Our reference: 1903-10396 SRA
Your reference: D/84-2014

Changed referral agency response—with conditions

project
**Riverside Waters Estate
Stages 1-12
Belmont Road, Parkhurst**

plan of
**Reconfiguration Plan
(222 Lots + Public Use Land)**

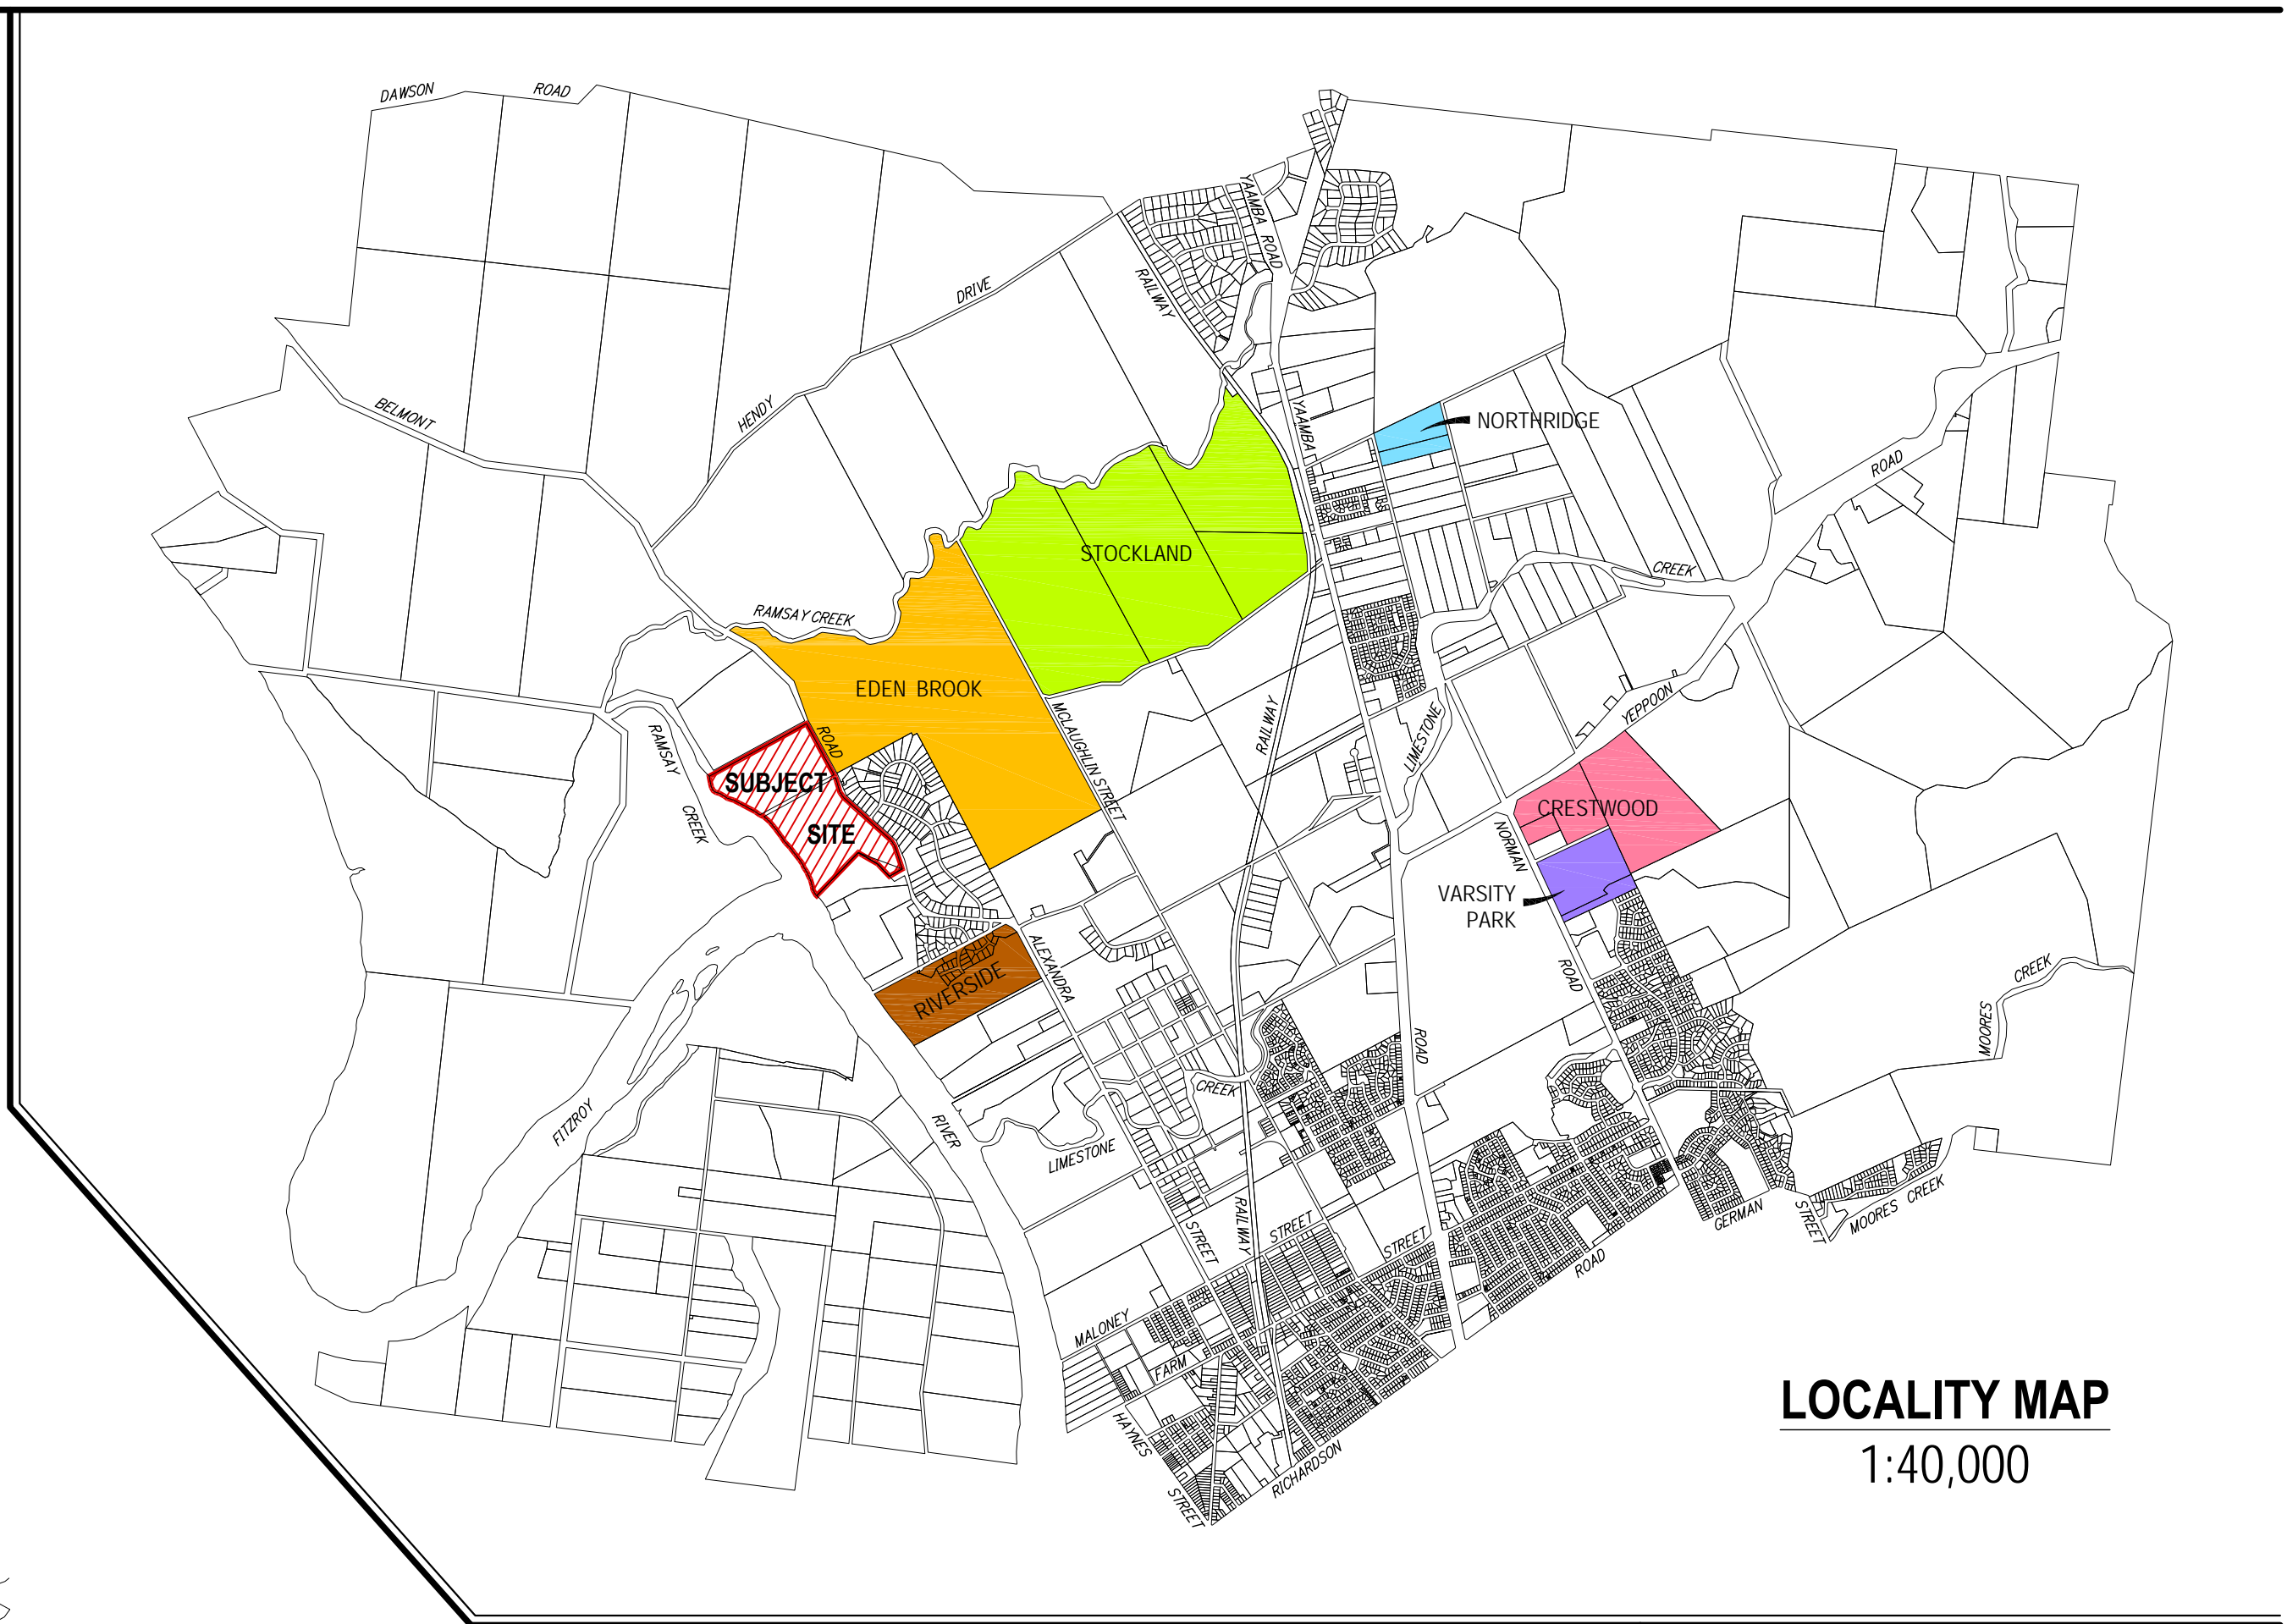
1.	<p>The development footprint must be carried out generally in accordance with the following plans:</p> <ul style="list-style-type: none"> - Reconfiguration Plan (222 Lots + Public Use Land), prepared by Capricorn Survey Group CQ dated 4/02/2019 reference 7066-01-ROL and revision B (as amended in red to show setback from the HES referable wetland). <p>Note: The HES referable wetland is the wetland shown on the map of referable wetlands as defined in the Environmental Protection Regulation 2008.</p>	Prior to submitting the Plan of Survey to the local government for approval

2.	<p>(a) Provide a development-free buffer for the purpose of maintaining the HES referable wetland's ecosystem functions and environmental values.</p> <p>(b) The buffer must be maintained for 50 metres from the mapped boundary of the HES referable wetland to development.</p> <p>Note: The HES referable wetland is the wetland shown on the map of referable wetlands as defined in the Environmental Protection Regulation 2008.</p> <p>Further information on buffer elements and the purposes of the buffer are set out in the -Queensland Wetland Buffer Planning Guidelines 2011</p> <p>https://wetlandinfo.des.qld.gov.au/resources/static/pdf/resources/reports/buffer-guide/wetland-buffer-guideline-14-04-13.pdf</p>	<p>[ROL] Prior to survey plan endorsement</p> <p>[MCU] Prior to commencement of use</p>

Amended in red by SARA on
14 May 2019
